**Subject: UNUM Provident Emergency Generator Pad  
Application for Project Modification**

**APPLICATION FOR PROJECT MODIFICATION**  
For Site Location and N.R.P.A. Projects

Name of Project: Emergency Generator Pad

From: "Rob Woodman" <rwoodman@DelucaHoffman.com>  
To: "Sarah Hopkins" <SH@portlandmaine.gov>, <JAYJR@po...>  
Date: Tue, Jul 12, 2005 9:48 AM  
Subject: RE: UNUM Provident Generator Model Modification

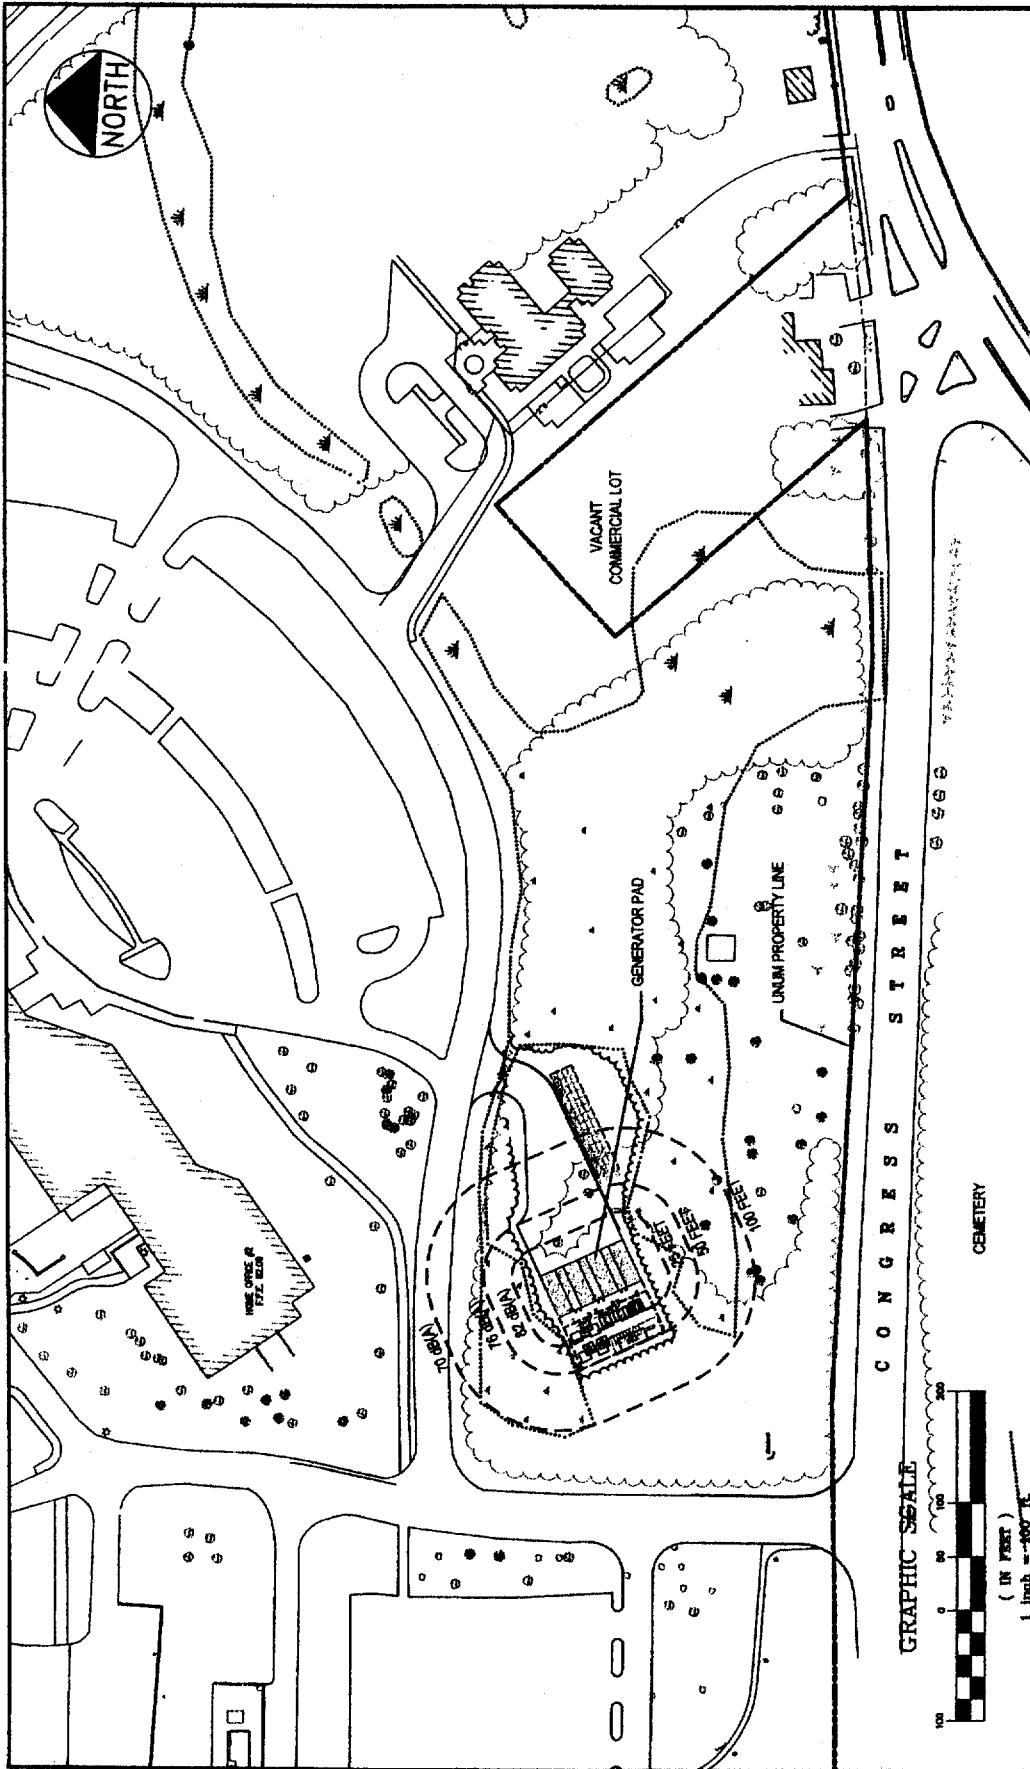
I have attached a copy of the Project Modification Application with submitted to the DEP on June 28 2005. The application shows a table with details on the noise at various distances from the generators and a figure showing these noise radii.

Rob,  
Could you ~~resend~~ the decibel attenuation information? We would be most interested in ~~any changes to~~ noise impacts.  
Thanks.  
-Sarah

I am in receipt of your project modifications for the new Generator. Can you give me more specifics as to how the additional plantings may reduce the sound that is generated? As you know the OP Zone states that the sound generated at the lot boundaries should not exceed 60 dBAs. I would like a like more assurances that requirement could be met.

Marge,  
Attached is a letter from Pritchard Brown's Engineering Department indicating that in their professional opinion the existing vegetation will result in a property line sound level of under 60 dB(A); therefore, any additional plantings will only help to further reduce the noise level.

Dwight,  
Thank you for the attached information. With this information, I have determined that you **will** be meeting the zoning requirements of the OP underlying zone. With my zoning sign-off, I believe that planning will be approving your site plan submittal. The next step would be to apply for a building permit for the work and then to build it.  
Thank you,  
Marge
